MUL Urban Design Memo #15

Date 30 March 2026

Subject: **Urban Design Response to Auckland Council Urban Design Feedback**

Figure 2.10 from MUL report with overlay identifying portions of T1 above and below the HEHCP. (H = total height of T1)

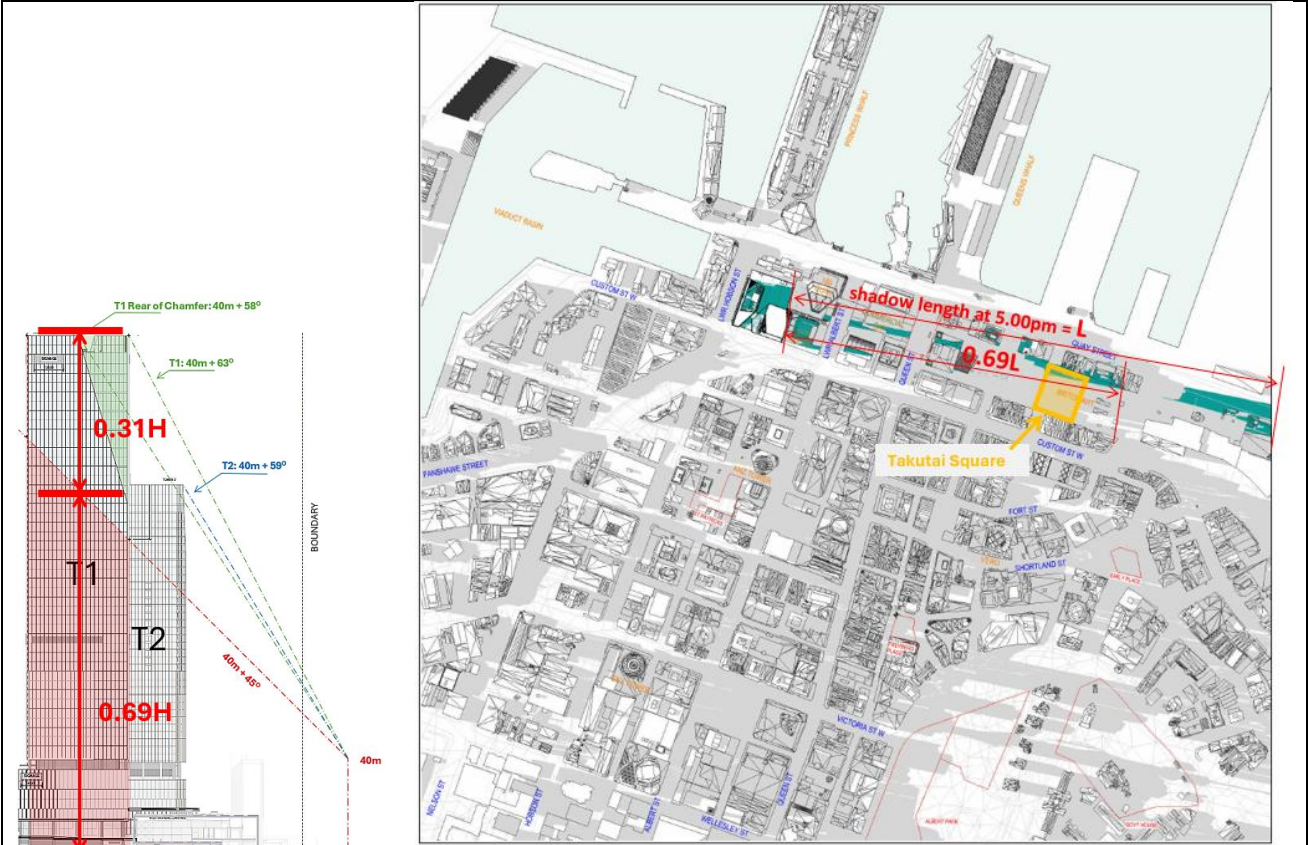
| Auckland Council feedback | Shading of identified public spaces MUL Urban Design Response – includes extracts from MUL UDA |
|---|--|
| <p>FTAA Downtown Car Park (25 Feb. 2026) Key shading concerns for the public open spaces remain: Takutai Square Equinox 5pm,</p> | <p>SHADING ON TAKUTAI SQUARE Takutai Square is not specifically identified by the Unitary Plan for sunlight control. Therefore, the following part of the Unitary Plan appears to be most relevant to this matter:</p> <p>H8.8.2 Assessment criteria (8A) infringement of the harbour edge height control plane standard: <i>(b) Amenity effects on the streetscape and adjacent public open spaces along the waterfront:</i> <i>(i) The extent to which building bulk above the harbour edge height control plane results in loss of amenity to adjacent public open spaces along the waterfront, including:</i></p> <ul style="list-style-type: none"> • Sunlight admission. <p>MUL Shading Assessment (page 40) “The proposal does cast shade over some other nearby public open spaces. In all cases the shading effect is limited to a specific time of year and when it is experienced, any additional shade is limited in extent and duration.”</p> <p>MUL Shading assessment at p67 for 5pm Spring Equinox 23 September. “At this time the sun is low. Shade is cast onto Tyler Street in Britomart, and beyond that over to Quay Street and into the port, from a point just to the east of Britomart Place. This shade is limited in extent and fleeting, however is over the last remaining area of sun on this street at the edge of Takutai Square at this time.”</p> <p>March 2026 observations: The shading effect at this time over Britomart and Quay Street beyond is rated in table 3.1 as ‘moderate’.” The overall significance of this shading effect on Takutai Square is rated as ‘negligible/low’. This is because:</p> <ul style="list-style-type: none"> • The ‘moderate’ rating for equinoctial shade referred to the entire area of shadow cast and adjustment must be made for considering only part of that; • Shading effects must be considered throughout the year and no shade will be cast on Takutai Square in either mid-summer or mid-winter; • The part of Takutai Square which is shaded at this time is Tyler Street and street carriageways are relatively insensitive; and • Takutai Square is not an identified space for sunlight control. <p>H8.8.2 (8A) (b) (i) suggests for the purpose of assessment of shade to waterfront public open spaces that there is a requirement to specifically determine the extent of shade from the parts of the building that is above the HEHCP. Graphic analysis below demonstrates that the shade on Tyler Street (assuming that is part of Takutai Square) arises from parts of T2 that are below the HEHCP. The rationale for this finding is:</p> <ol style="list-style-type: none"> a) Measured at the centreline of the building, that part of T1 below the HEHCP is the lowest 69% of building height. (see annotated extract form figure 2.10) b) The plan diagram shows that the shade cast over Tyler Street will be from the rear half of T1. The centreline of T2 is at 0.686 of the height (H), rounded to 0.69H |

| | <p>c) As the length of shadow has a direct linear relationship to the height of the building, the shadow cast by the uppermost 31% of T1 can be identified, and it is well beyond Takutai Square at this time.</p> <p>d) Because the length of the shadow in the Sep 23 – 05_00PM shading diagram is truncated by the frame of the drawing, the point where shade from the infringing top of the building occurs will be further beyond Takutai Square than shown on this diagram.</p> |

Sep 23 - 05_00 PM
Warren and Mahoney shading diagram with overlay which demonstrates that the shade from the part of the part of T1 that is above the HEHCP does not impinge on Takutai Square at this time.
